# CZ-MP-23-04 Homestead at Bryan Farm

Town Council

October 8, 2024

Request: Tier 2 conditional rezoning request submitted by the Lennar Corporation to rezone 99.17 +/- acres from Rural Agricultural (RA) to Residential 8 (R8 C306) Conditional for the development of a collective maximum of 256 dwelling units (*note: down from 291 in the original application*) including individual maximums of **98** townhouse units and **158** single-family detached units. This site is located on the west side of Hebron Church Road and north of Clifford Rd. Zoning conditions restricting range of permitted uses and adding commitments above and beyond the requirements of the UDO included.

homestead at bryan farms  
Garner, Wake County  
SC-2023-158

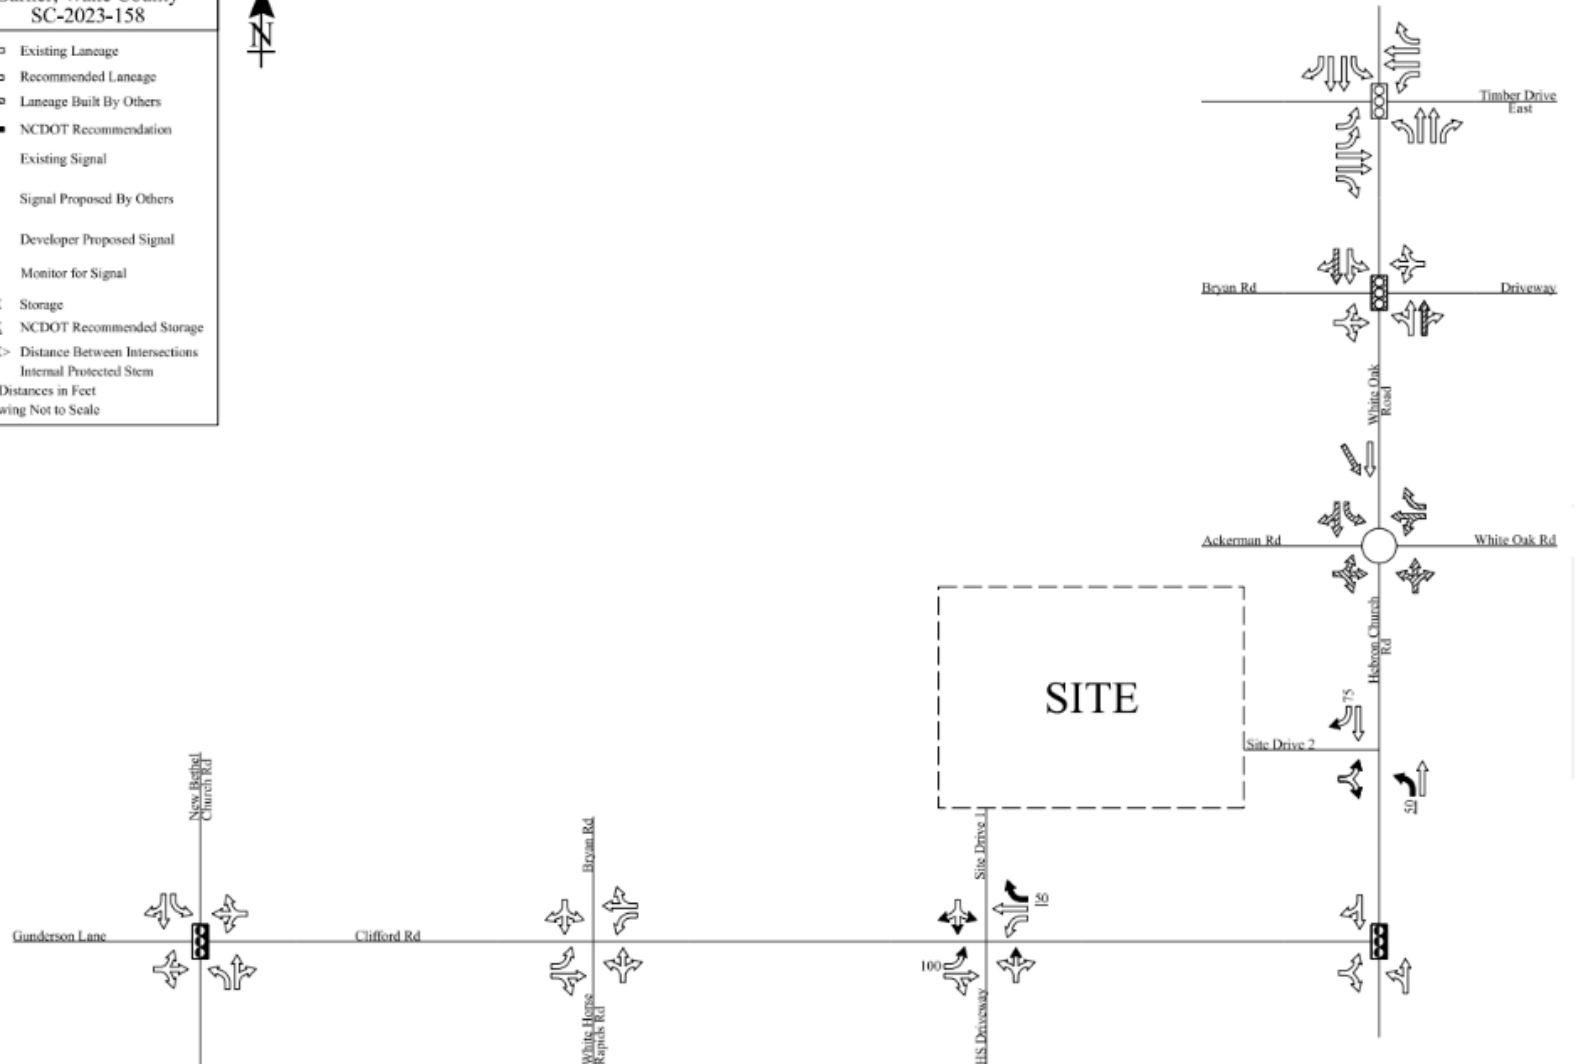
- Expected 2,313 trips on the average weekday (based on 265 units – 9 units higher than final).
- No off-site improvements are recommended as needed to reflect the limited proportional impact of the added traffic generated by this proposal.
- Figure shows the 2027 future build out lane configuration and the requirement for a new 50-foot dedicated northbound left turn lane on Hebron Church Road and a new 50-foot dedicated westbound right turn lane on Clifford Road.

GROWTH FRAMEWORK CONSISTENCY

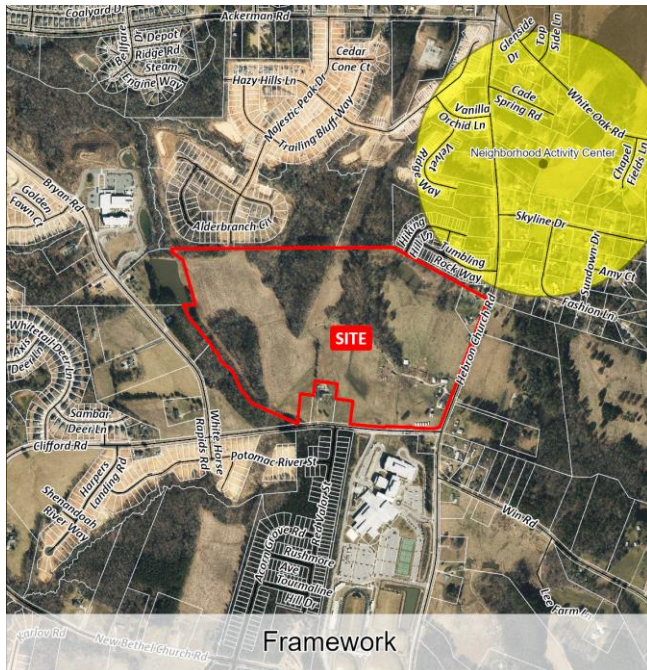
- 13 strongly consistent
- 1 modestly consistent
- 1 split
- 0 modestly inconsistent
- 2 strongly inconsistent - Front loaded townhouses; form of small lot single-family detached houses

LAND USE AND COMMUNITY CHARACTER CONSISTENCY

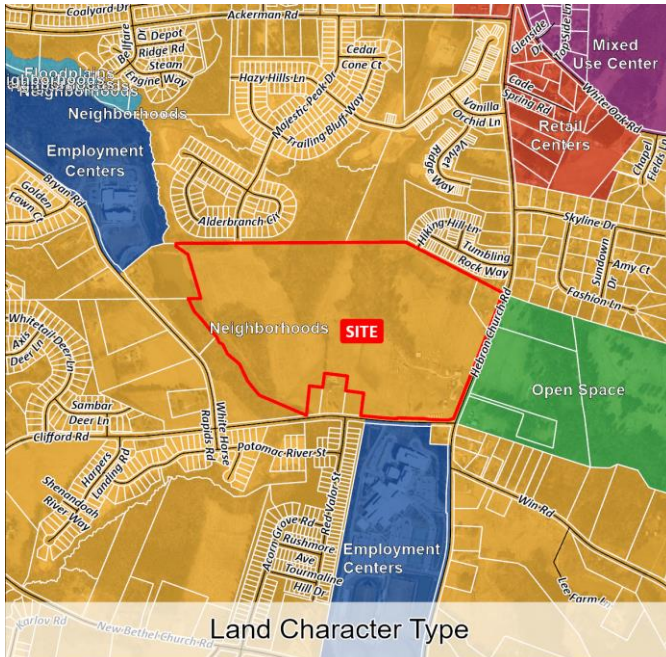
- 6 strongly consistent
- 15 modestly consistent
- 3 split
- 0 modestly inconsistent
- 2 strongly inconsistent – lack of green street solutions, lack of home choices for those in plan-targeted demographics
